DSOX2002A-03

S E R V I C E N O T E

DSOX2002A – Oscilloscope, Mixed Signal, 2 Channel,
70MHz

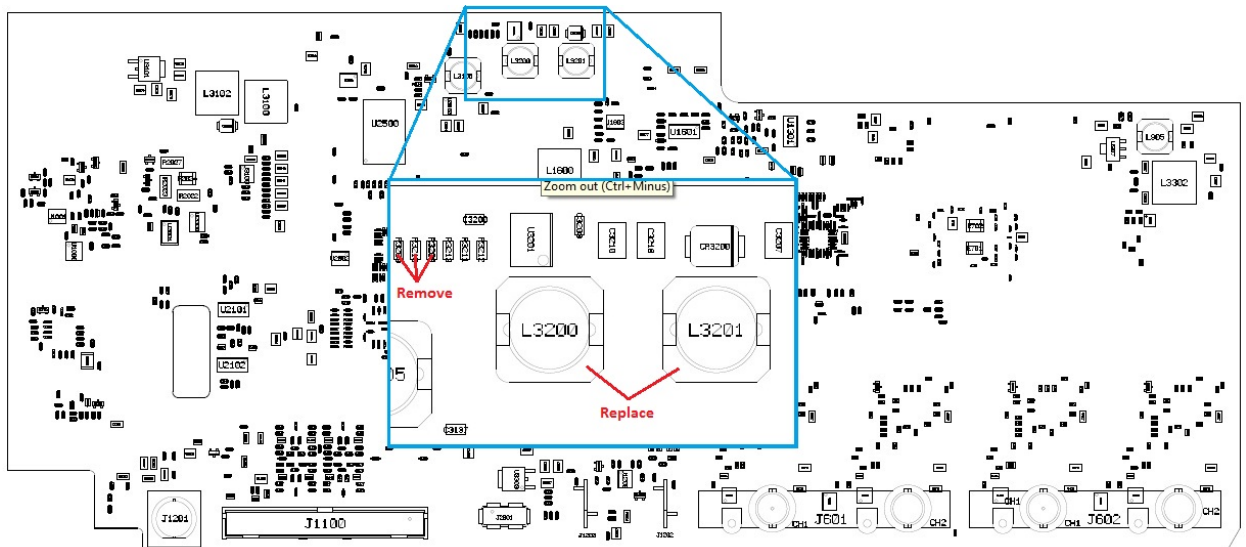
With the oscilloscope power turned on and while under normal operation, the unit emits a hissing noise.

2. As the picture indicates, remove the three resistors (0699-7209, 1 Ohm) located at R3208, R3209, and R3210. They are not to be replaced.
3. Remove as well the two inductors (9140-6474, 100uH) located at L3200 and L3201 and replace them with inductors with part number 9140-6151 (68 uH).
4. Re-assemble to the point where the unit could be powered up to verify that the hissing is indeed gone. If the hissing is not gone, please, check modifications.
5. When the hissing is gone, put oscilloscope back together.
